Wichtiger Hinweis –vor der Installation lesen!

Important Notice – read before installation!

When using current IS1+ sockets of versions 9490/1*-12 with hardware **Rev. B** in combination with the CPM units 9440/22 and firmware **V0x-52** or earlier, some special characters are displayed incorrectly on the display of the socket:

Position der Hardware-Revision beim Sockel 9492 und der Firmware Version beim CPM 9440/22:

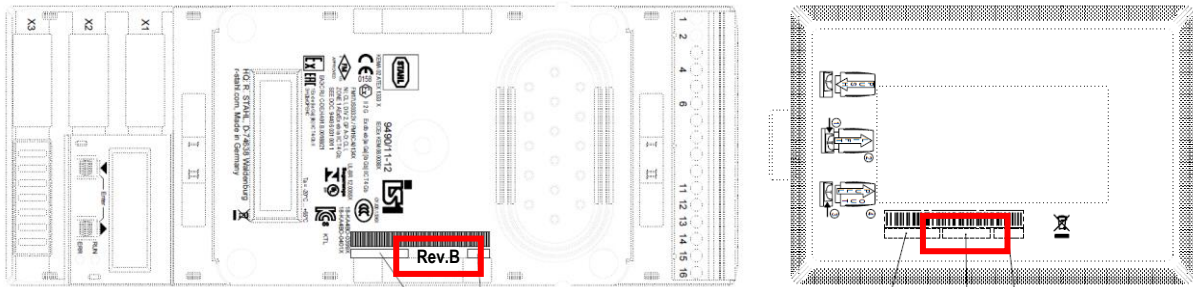
Bei Verwendung aktueller IS1+ Sockel der Ausführungen 9490/1*-12 mit Hardware **Rev. B** in Verbindung mit den CPM Baugruppen 9440/22 und Firmware **V0x-52** oder früher werden einige Sonderzeichen auf dem Display des Sockels falsch dargestellt:

Die CPM Baugruppe 9440/22 muss mit Firmware **V0x.53** oder höher betrieben werden. Die Firmware Version kann über die Kennzeichnung am CPM (siehe Abbildung, oben rechts), über PROFIBUS I&M Funktionen (z.B. mit dem IS1+ DTM) oder über den IS Wizard ermittelt werden.
